**Subject:** Submittal of Replacement Pages to Update the NAC-UMS<sup>®</sup> FSAR from Revision 4 to Revision 5 (Docket No. 72-1015)

**10 CFR 72.48 Evaluation Summary Report**

**NAC-UMS<sup>®</sup> Universal Storage System  
(Docket No. 72-1015)**

<b>NAC INTERNATIONAL</b>		
REINFORCING BAR AND CONCRETE PLACEMENT, VERTICAL CONCRETE CASK (VCC) NAC-UMS®		
PROJECT	790	DRAWING
		562
		REV 16
		SH 6 OF 7

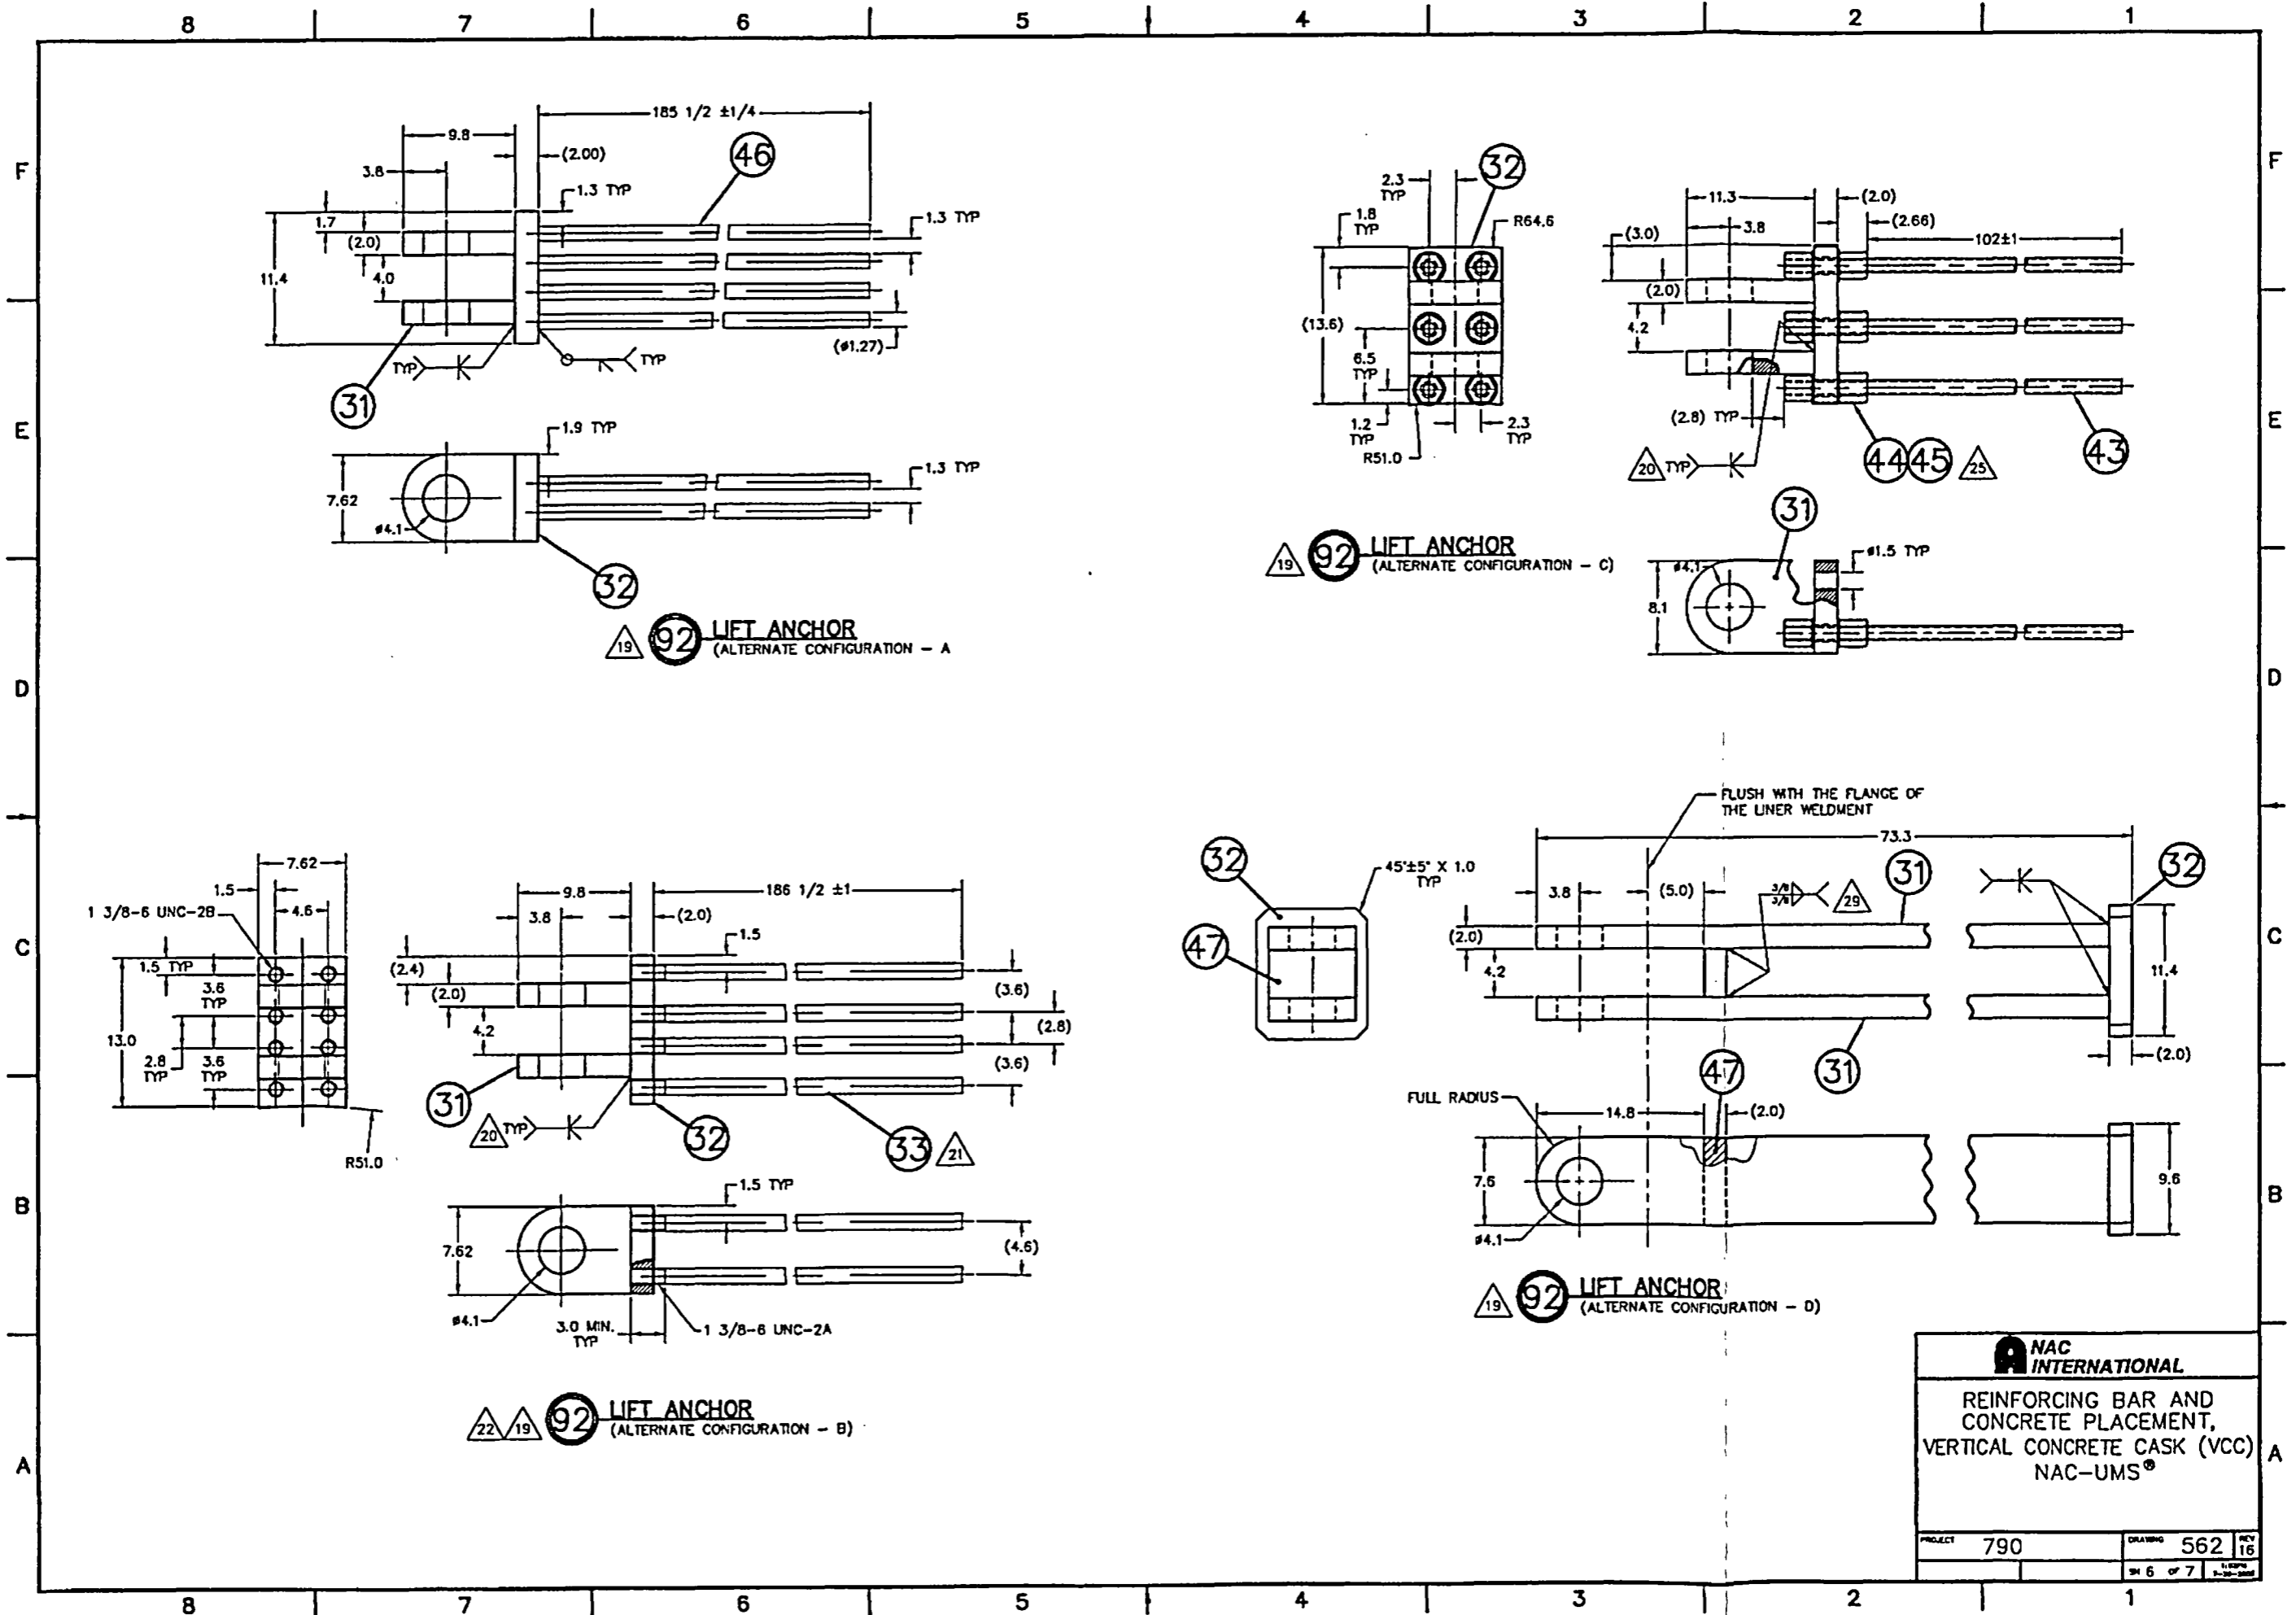
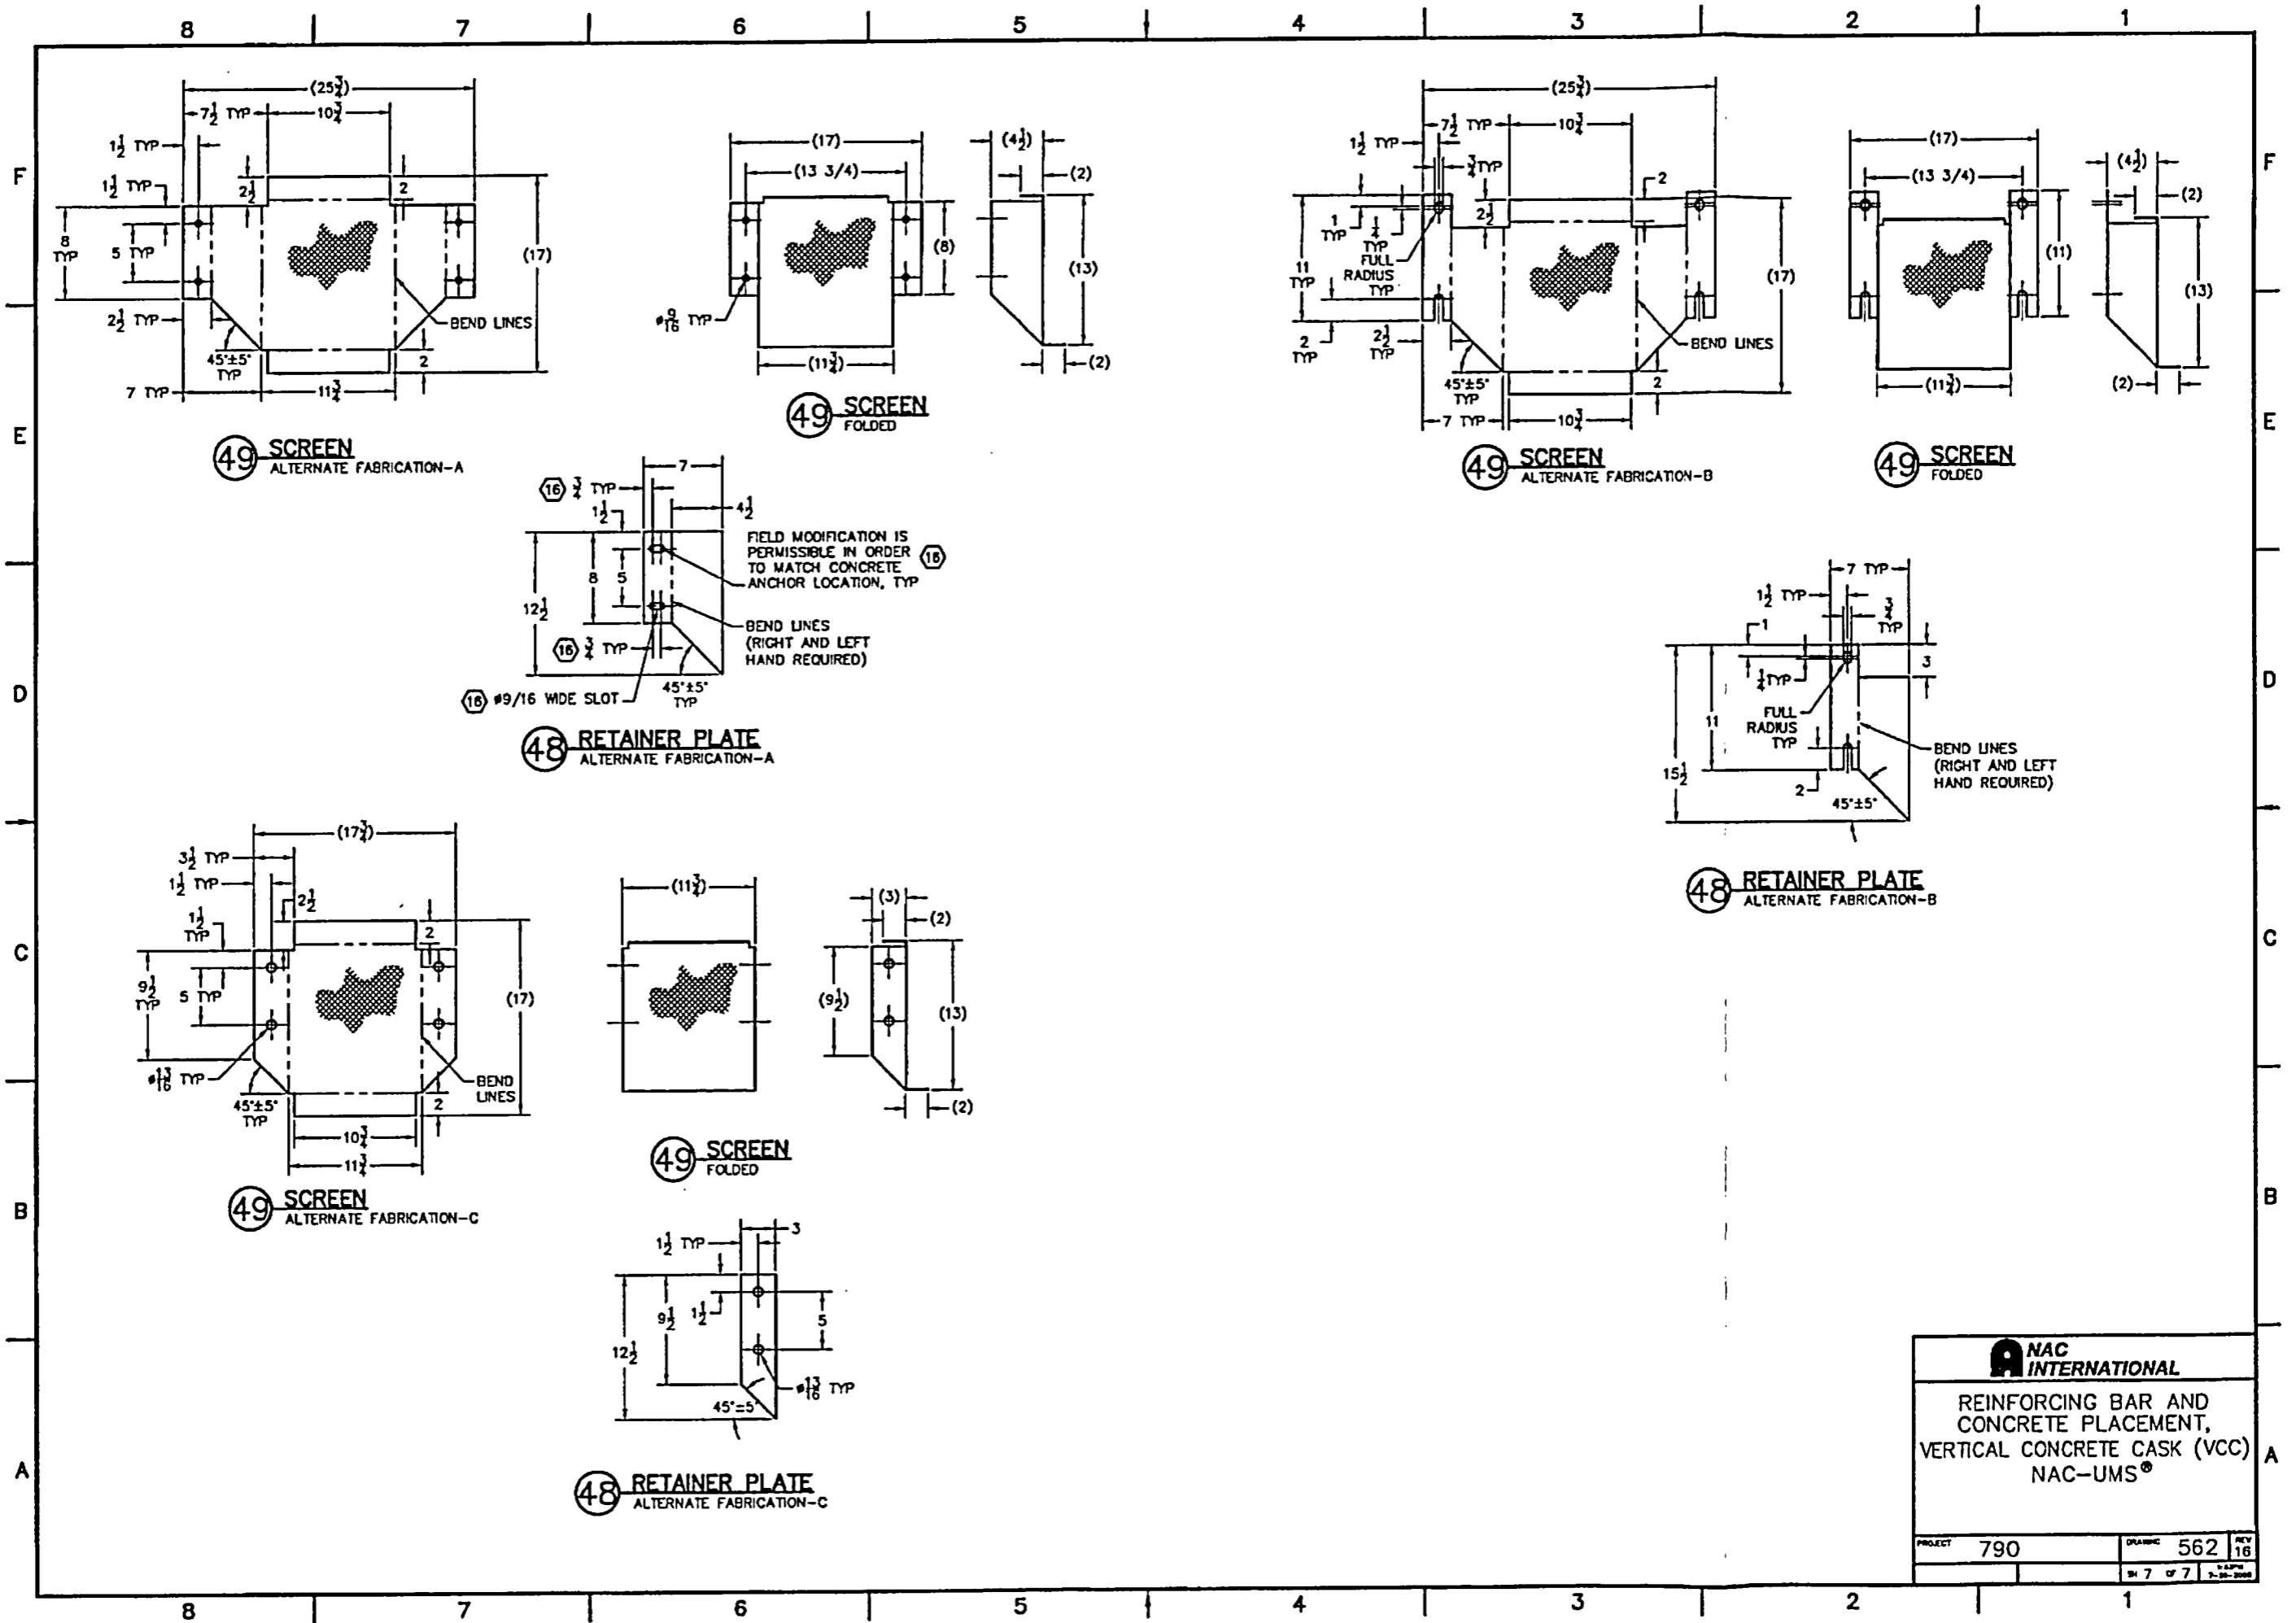
Revision 15 of Drawing 790-562 adds an “Optional Drain Hole (one per quadrant)” to the side of the inlet opening, in Section B-B.

Revision 16 of Drawing 790-562 changes Item 48, Retainer Plate, Alternate Fabrication-A (Sht 7 of 7, Zone D-6).

This drain hole will provide a path for water drainage in the cavity formed by the vertical concrete cask bottom plate, inlet sides, shell liner, stand, and the shield ring. The addition of this feature (a drain hole in the side of the air inlet) is insignificant as related to the structural and shielding calculations and will not affect the form, fit or function of the Base Weldment and/or other vertical concrete cask components.

This change will allow the concrete anchor and anchor mounting hole to be moved away from the edge of the concrete (near the side of the inlet tunnel). If the mounting hole is too close the edge of the concrete, the thin wall section of concrete between the mounting hole and inlet weldment crumbles. This results in the need to glue the anchor in place with an adhesive product and repair the crumbled concrete.
